JMHLTR: #98-0195

Subject: Jet Pump Riser 15/16 Weld Flaw Evaluation
Dresden Nuclear Power Station, Unit 2
NRC Docket No. 50-237

Attachment 1
Response to Request for Additional Information
Dresden Station Unit 2
50-237

JP 15-16
RS-1
245 DEG

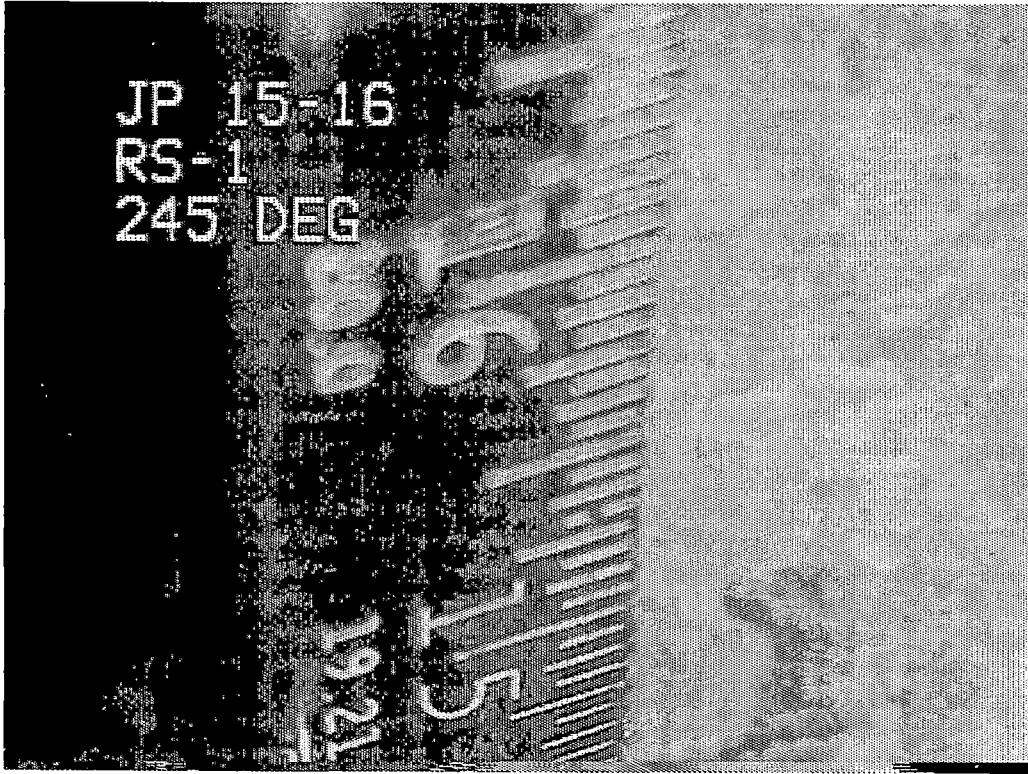
Measurement uncertainty (page 8)-Provide the measurement uncertainty used in determining the measured flaw length. Explain how the uncertainty was established.

The flaw was discovered and examined using an enhanced visual technique with a 0.0005" wire resolution. It was sized using a graduated steel scale with 1/16" increments. The flaw is less than 1.5" in overall length and has been captured in a single image, a copy of which is attached. (Note: The photo has been reproduced from the SVHS file tape and has thus lost some resolution in reproduction.) The OD of the riser is reasonably flat over the tangential length of the flaw as shown on the photograph. Since the measured length was conservatively determined no additional uncertainty was required.
